Amendments to the Drawings

Attachment: Replacement Sheet
Annotated Marked-Up Drawings

Figure 2

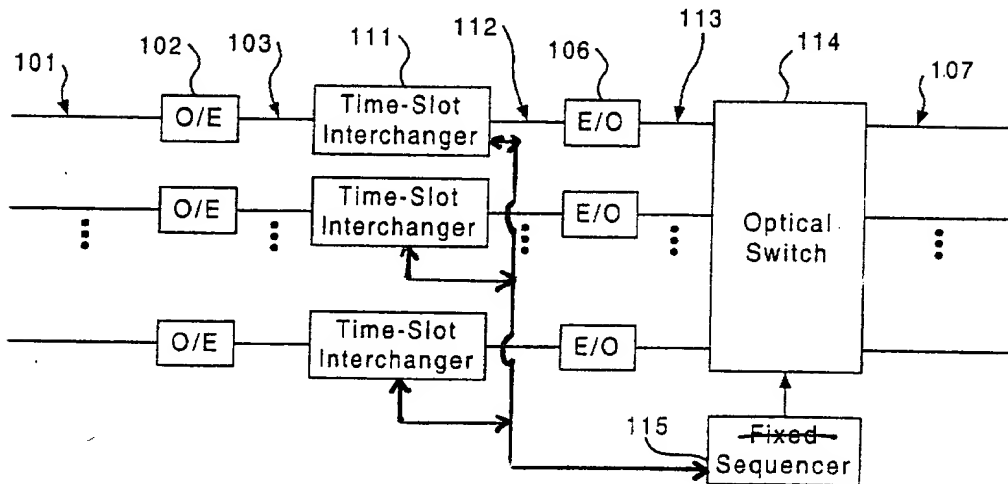
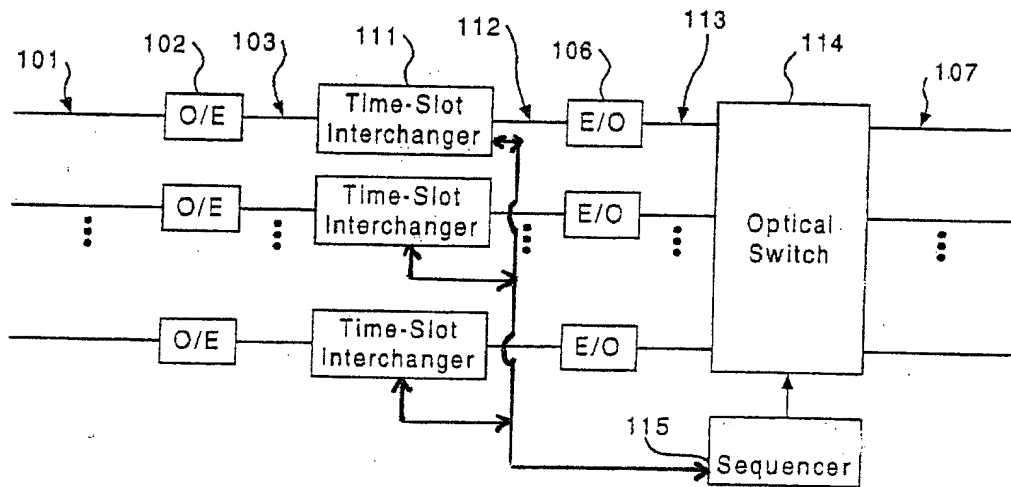
Figs. 2 and 3 have been amended to replace “Fixed Sequencer” with “Sequencer.”

Figs. 2 and 3 have also been amended to include bi-directional arrows between sequencer 115 and the time slot interchangers 111 to illustrate a communication link between the two elements.

Support for these amendments are found at least in page 4, lines 6-15; page 6, lines 1-2, and page 6, line 17.
